**SUBJECT :** ADDENDUM NO. 1  
**PROJECT:** KEMP ROAD SIDEWALKS PROJECT;  
PID 110374  
**DATE:** JANUARY 16, 2024

GRE-CR 40-1.04  
KEMP ROAD SIDEWALKS

SIGNAL GENERAL NOTES

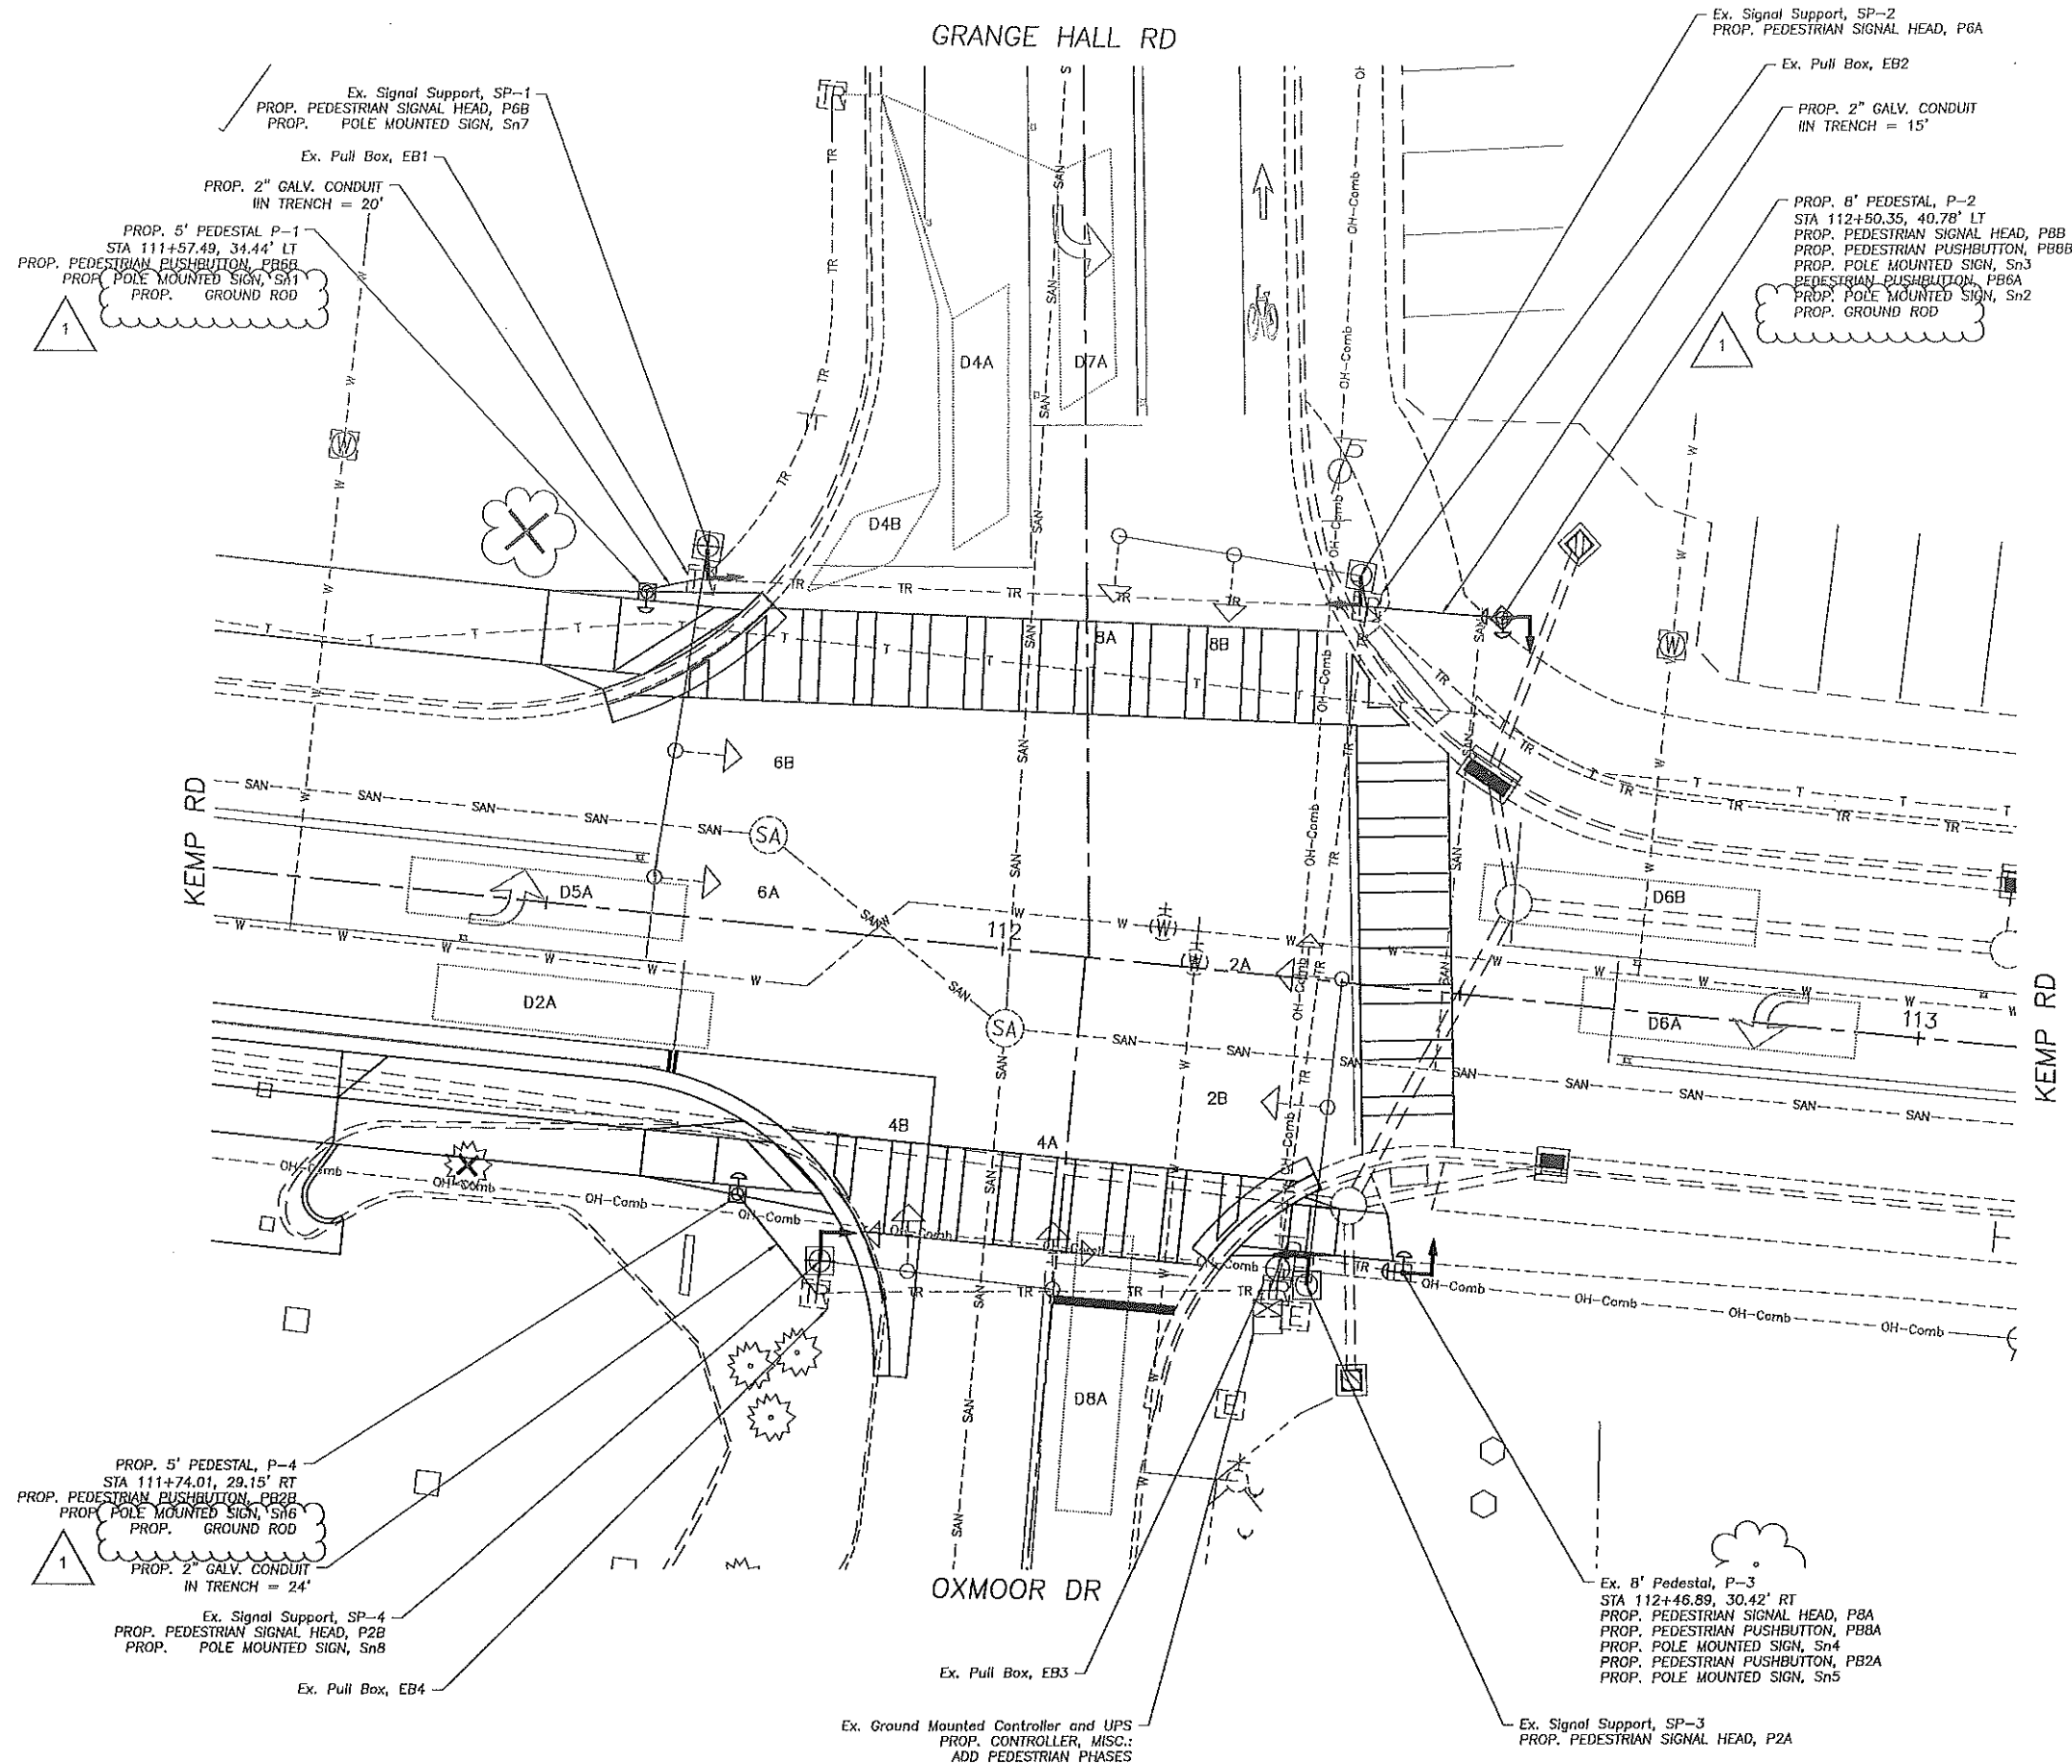
- A.** Changes have been made to page 10. An item and quantities have been added for Item 625 - Ground Rod to the project.
- B.** Changes have been made to page 33. Plan notes have been added for Item 632 - Pedestrian Pushbuttons, As Per Plan.
- C.** Changes have been made to page 34. Proposed Ground Rod locations have been added to the plan.

- A.** A question was asked about Ground Rods missing from the plans and proposal sheets. These items have been determined to be needed for the project. Plans and proposal items have been updated to include Ground Rods.
- B.** No As Per Plan notes were included in the plans for Item 632 - Pedestrian Pushbuttons, As Per Plan. Plan notes have been included in the plans for this item.

632. PEDESTRIAN PUSHBUTTONS, AS PER PLAN

FURNISH PUSHBUTTONS OF STURDY CONSTRUCTION THAT CONSIST OF A BASE HOUSING AND A REMOVABLE COVER. FURNISH COMPONENTS THAT PROVIDE A PUSHBUTTON WITH NORMALLY OPEN CONTACTS AND THAT INCLUDE ALL ELECTRICAL AND MECHANICAL PARTS REQUIRED FOR OPERATION.

ENSURE THAT THE DESIGN OF THE PUSHBUTTON AND ITS ASSOCIATED CONTACTS AND HOUSING ARE STURDY AND RESISTANT TO MECHANICAL SHOCKS AND ABUSE. ENSURE THAT A CONCENTRATED FORCE OF 50 POUNDS (225 N) APPLIED TO THE BUTTON OR ANY EXPOSED PORTION DOES NOT DAMAGE THE UNIT OR MISADJUSTS THE CONTACTS. FURNISH A HOUSING WITH A CURVED BACK SURFACE FOR MOUNTING ON POLES OF VARIOUS DIAMETERS. INTEGRATE THE CURVED SURFACE WITH THE HOUSING OR SUPPLY AN ADAPTER WITH A FLAT BACK TYPE HOUSING. ATTACH THE COVER ASSEMBLY TO THE HOUSING BY STAINLESS STEEL MACHINE SCREWS, RESULTING IN A WEATHERPROOF AND SHOCKPROOF ASSEMBLY. FURNISH A HOLE THREADED FOR A 1/2-INCH (13 MM) PIPE IN THE HOUSING FOR CONDUIT ATTACHMENT PURPOSES. FURNISH HOUSING WITH MANUFACTURERS APPLIED EXTERNAL SURFACES BLACK COLOR 1703B OR YELLOW COLOR 13655, FEDERAL STANDARD 595, UNLESS SPECIFIED OTHERWISE IN THE PLANS.

THE PUSHBUTTON SHALL BE A MINIMUM OF 2 INCHES ACROSS IN AT LEAST ONE DIMENSION. THE FORCE REQUIRED TO ACTIVATE THE PUSHBUTTON SHALL BE NO GREATER THAN 3.5 POUNDS (15.5N) AND OPERATE WITH A CLOSED FIST. THERE SHALL BE A VISIBLE AND AUDIBLE INDICATOR THAT THE BUTTON PRESS HAS OCCURRED.
